February 7, 2022

File: 2697-22A R2

**Re: Carey Theological College Additions
Noise from Rooftop Mechanical Equipment**

Figure 1: VRV Units and Screening on Rooftop of Existing 2005 Building

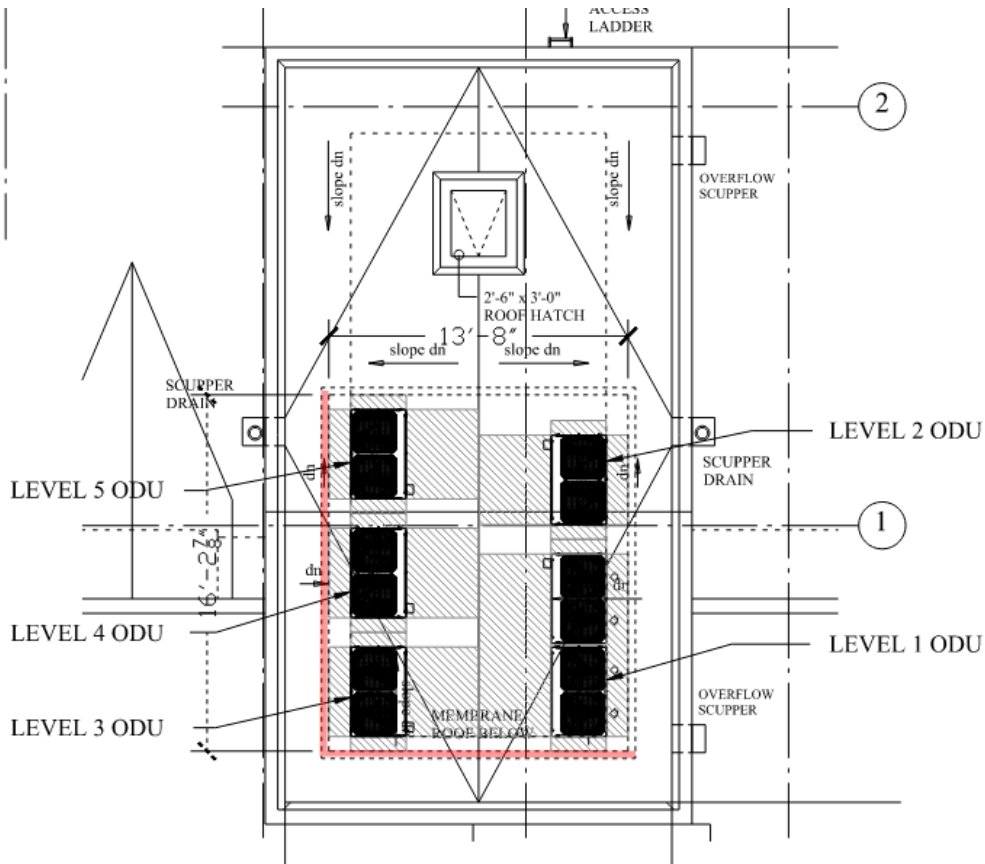
We have assumed that all of the new rooftop equipment may operate simultaneously during nighttime hours so the applicable noise limit at Points of Reception is 45 dBA. Although the drawings show 2 metre high architectural screens surrounding all of the new rooftop equipment, we assumed initially, that they may be perforated or louvred and only effective visually. Hence, they were not accounted for in the initial modelling. However, the initial modelling results indicated that 45 dBA would be exceeded at some locations. Therefore, we have recommended that at least some portions of these 2 metre high screens should be solid in order to provide additional sound attenuation.

Predicted sound levels, assuming that solid screens are provided as indicated in Figures 1, 2 and 3, are shown in Figure 4. The solid sections required are indicated by red lines in Figures 1, 2 and 3. The one additional screen on the rooftop of the Lot 40b Building, between the VRV units and the heat pumps is necessary because it needs to be close to the heat pumps in order to provide sufficient sound attenuation.

The solid screens could utilize almost any material having a surface weight of at least 2 lb/ft² (10 kg/m²). For example, steel, aluminum or transparent panels formed of plastic polymers could be used as long as they have an impervious surface with a negligible number of holes or cracks (< 0.2% of total area) and they have the required surface weight. Ideally, there should be no gap along the bottom edge but a few scuppers could be provided for drainage if required. If the architectural screens that are already shown on the drawings do not meet these requirements, they could be retained but backed by a solid layer at the required locations, thereby retaining a consistent visual appearance from an outside viewpoint.
